A-25:133 — 40 Church Street, Ancaster

**STAFF COMMENTS**

**HEARING DATE: August 14, 2025**

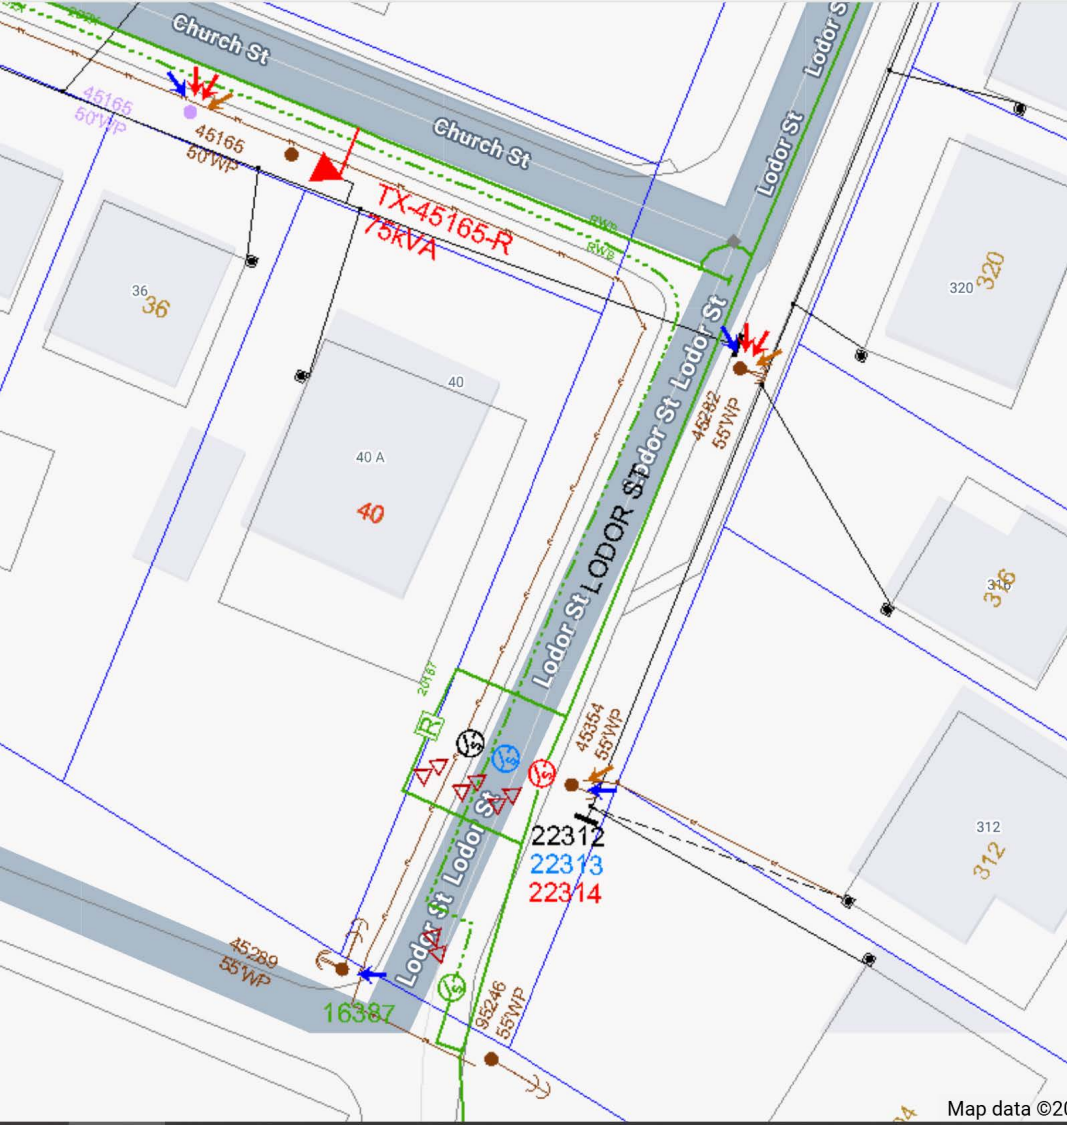
- For Subdivision or Townhouse development, the Developer needs to contact our Engineering Design Department @ 905-798-3234.
- Minimum 4m horizontal clearance from existing O/H line(s) must be maintained at all times as per Alectra Utilities Standard 3-105. Please consult with Alectra Utilities if further clarification is required.

- Existing O/H secondary service is in conflict with existing large balcony on the proposed conversion of this property exposing tennents or public to possible electrical contact risk and must be immediately relocated to meet the Electrical

Safety Authority clearances of 3.1m for energized services over a roof or patio immediately.
